SERVICE BULLETIN

DATE: 15 SEPTEMBER 2006
PAGE 1 OF 6

INTEGRATED INSTRUMENT DISPLAY SYSTEM (IIDS) EEC LIGHT WIRING MODIFICATION

MD900 Helicopters, serial numbers 900-00088 thru 900-00110, 900-00113 and 900-00114.

Figure 1. IIDS Signal Correction Modification Wiring Diagram

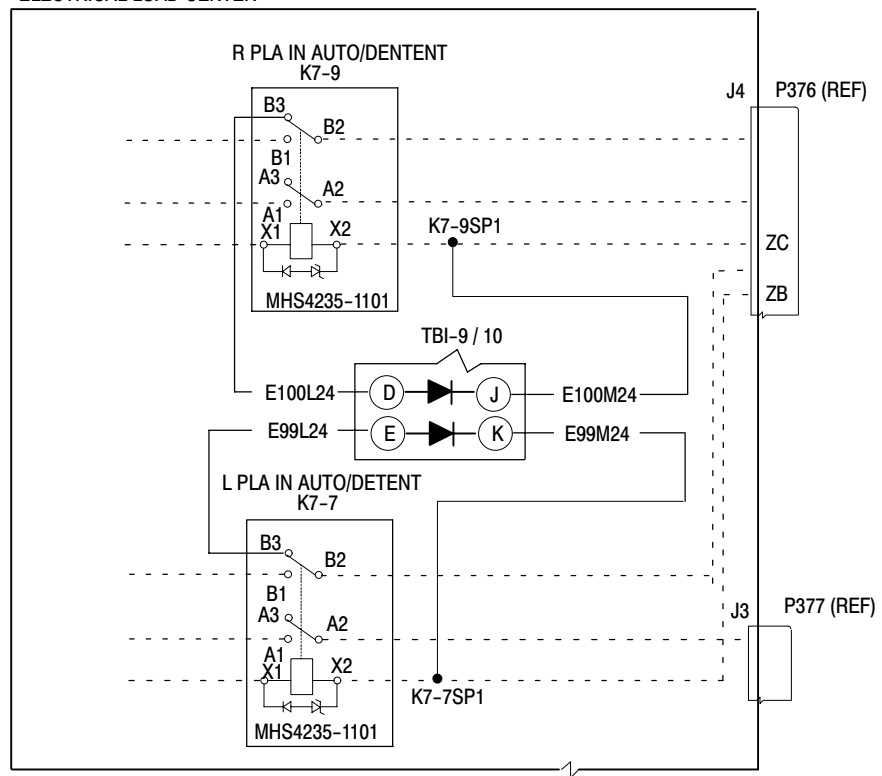
The IIDS Electronic Engine Control (EEC) lights unintentionally blink when power is supplied by the essential bus. Failure to comply with this Bulletin may result in pilot distraction during dual generator failure emergency procedures.

Procedures in this Bulletin provide owners and operators with information pertaining to modification of the wiring to ensure the correct signals are applied to the IIDS when the Electrical Master Power switch is in the ESNTL position.

(Ref. Figure 1)

- (1). Remove A620 left cover and lower circuit breaker panel (Ref. CSP-900RMM-3, Section 96-30-00, Electrical Load Center).
- (2). Locate wire segment between A620 J4-ZB and A620 K7-7 X2.

- (3). Install splice A620 K7-7 SP1 on wire segment within 6 in. (152.4 mm) of A620 K7-7. Insert wire segment from A620 J4-ZB and wire segment from A620 K7-7 X2 into splice prior to crimping.

- (4). Install wire E99M24 EMI 3 from A620 K7-7 SP1 to A620 TB1-9/10 K.
- (5). Locate wire segment between A620 J4-ZC and A620 K7-9 X2.
- (6). Install splice A620 K7-9 SP1 on wire segment within 6 in. (152.4 mm) of A620 K7-9. Insert wire segment from A620 J4-ZC and wire segment from A620 K7-9 X2 into splice prior to crimping.

- (7). Install wire E100M24 EMI 3 from A620 K7-9 SP1 to A620 TB1-9/10 J.
- (8). Install wire E99L24 EMI 3 from A620 K7-7 B3 to A620 TB1-9/10 E.
- (9). Install wire E100L24 EMI 3 from A620 K7-9 B3 to A620 TB1-9/10 D.

- (10). Install sleeving over splices A620 K7-7 SP1 and A620 K7-9 SP1 for chafe protection.
- (11). Tie added wires into A620 assembly electrical load center wire harness W620.
